# Groundwater Application Review Summary Form

Application # G- 19464

GW Reviewer James Hootsmans Date Review Completed: 1/31/2025

TO: Water Rights Section Date 1/31/2025  
 FROM: Groundwater Section James Hootsmans  
 Reviewer's Name  
 SUBJECT: Application G- 19464 Supersedes review of \_\_\_\_\_  
 Date of Review(s)

Water-Level Measurements in Nearby Wells (for wells deeper than 250 feet)

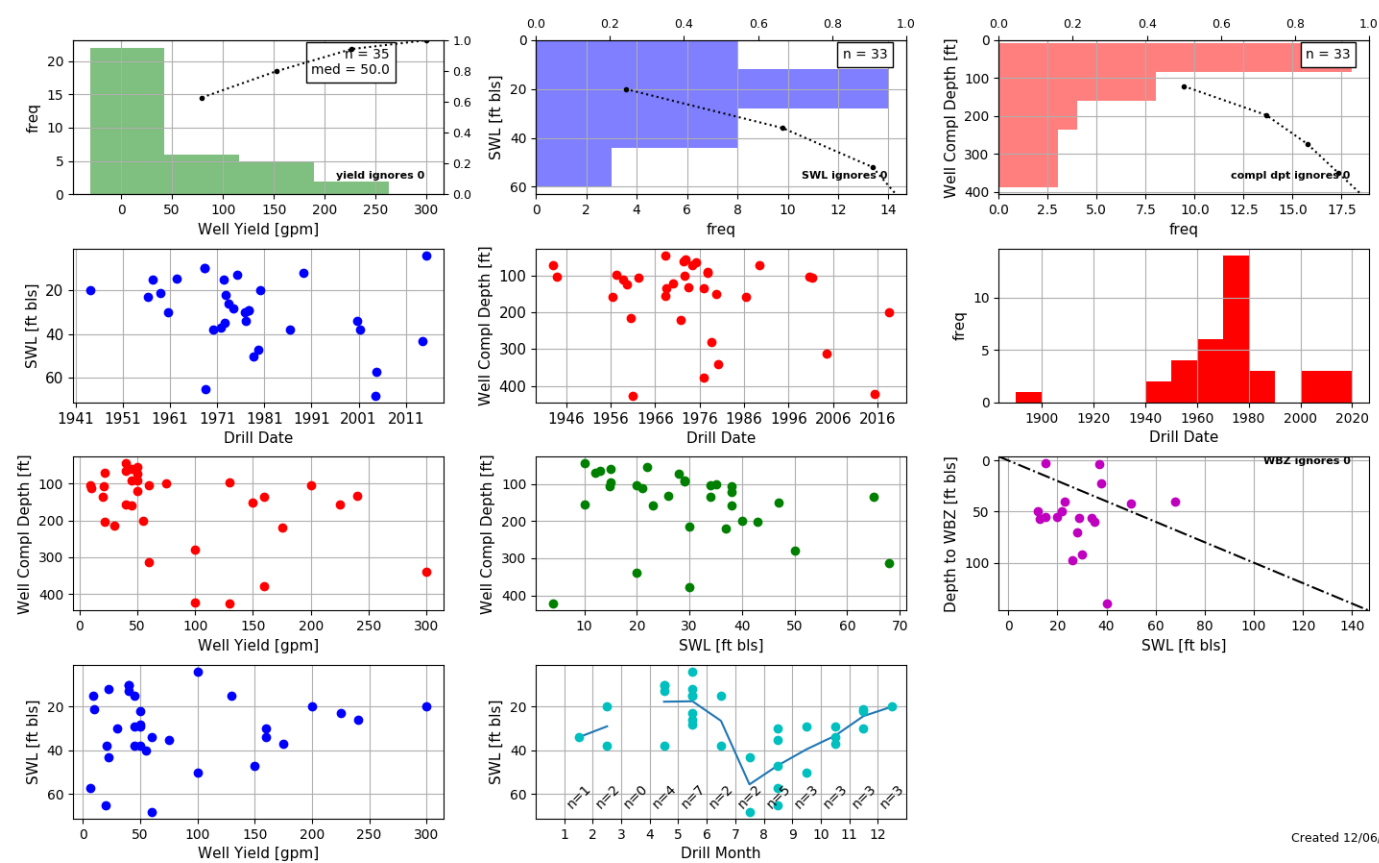
A review of the currently available water level data in the vicinity of the POA indicates that the requested maximum rate is within the capacity of the resource (See Observation Well Data). There are slight declines in CLAC 2555 and 56198, two of the deeper alluvial wells near the POA, but declines are not excessive. CLAC 2538 and 60296 also exhibit overall declines, but the period of record is not current. Although overall precipitation has declined, the local water levels do not appear to track well with precipitation.

In order to protect senior users and the groundwater resource, the conditions specified in B1(d)(i) and B2(c) are recommended for any permit issued pursuant to this application.

## Theis Model

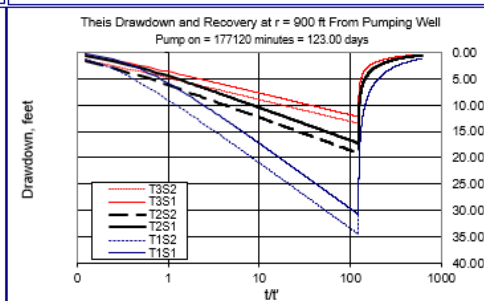
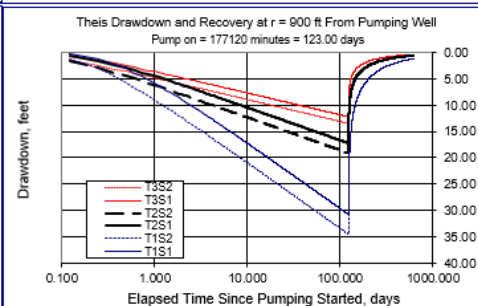
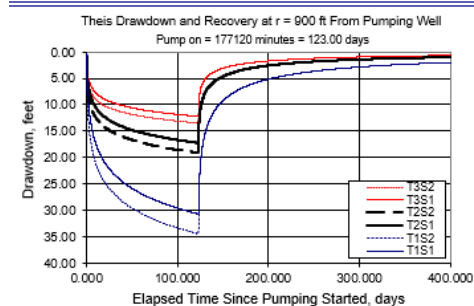
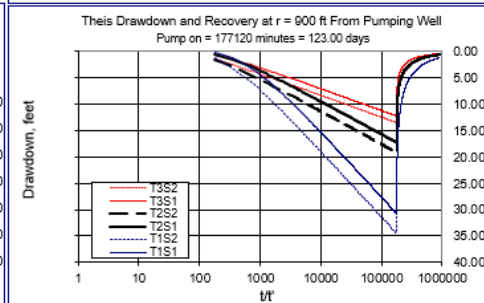
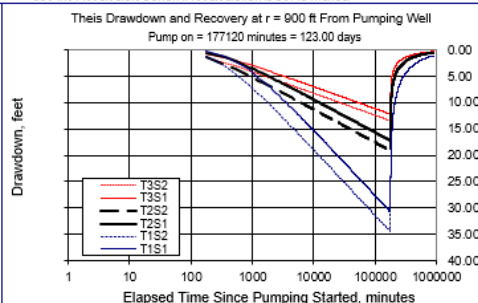
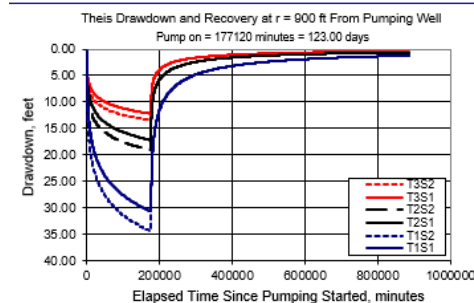
A Theis (1935) drawdown analysis was conducted to assess the potential well-to-well interference with CLAC 2538 due to pumping of the proposed POA in the amounts requested in this application and G-19199. The period of the non-storage season, July 1 to October 31, was used for the analysis. Hydraulic parameters used for the analyses were derived from regional data and studies (Pumping Test Reports; Conlon et al., 2003, 2005; Iverson, 2002; Woodward et al., 1998) or are within a typical range of values for the parameter within the hydrogeologic regime (Freeze and Cherry, 1979).

Results indicate that the proposed use is not likely to cause well-to-well interference with CLAC 2538 that exceeds the threshold under the standard condition for alluvial aquifers in the Willamette Basin.
